REVIEW COMMENTS / PP-2003-067 / PAGE 9 of 9

Re: PP-2003-067
FORREST GLEN SUBDIVISION

SUBJECT: Response to Comments – Forrest Glen
Subdivision (PP-2003-067).

Forrest Glen Subdivision
FILE #PP-2003-067

**PROPOSED
McCALDON WAY
URBAN RESIDENTIAL STREET**
(WITH DRIVE OVER CURB, GUTTER AND SIDEWALK)
N.T.S.

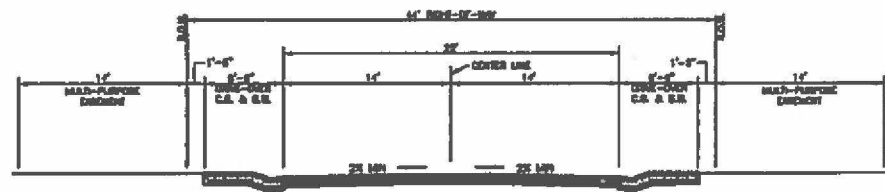
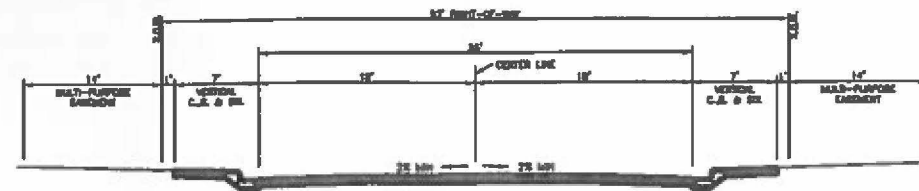
- * McCaldon Wy. water line must be 8".
- * Petitioner must provide an engineered drawing of off site improvements.

Response: McCaldon Way's water line has been revised as an 8" line on the preliminary plan. The petitioner will take the Ute Water's comments into consideration during the final design of the subdivision..

**FIGURE 29 ROAD IMPROVEMENTS
PRINCIPAL ARTERIAL**
(30' ON-SIDE FRONTAGE)
N.T.S.

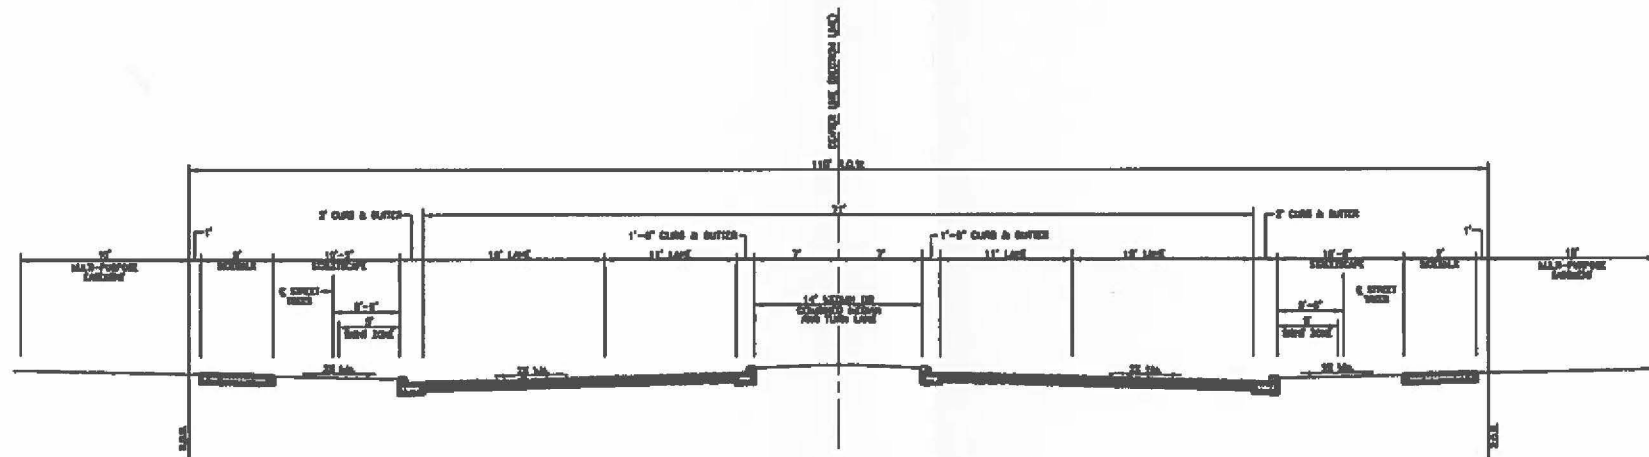
2. The dimension of pavement width along 29 Road indicates a half-street pavement width of 35' as measured from the section line. Scaling the drawing indicates that the actual proposed width is 35.5', which is the correct half-street dimension. At Final Plan, please update this dimension accordingly, and provide a dimension for the proposed half-right of way, as was requested in the first round of comments.

3. At Final Plan, the developer must demonstrate that the pavement taper ratios for the 29 Road improvements meet minimum requirements, and the tapers must be labeled. Also, the City Transportation Engineer may require the developer to provide a detailed striping plan for the street improvements along 29 Road.
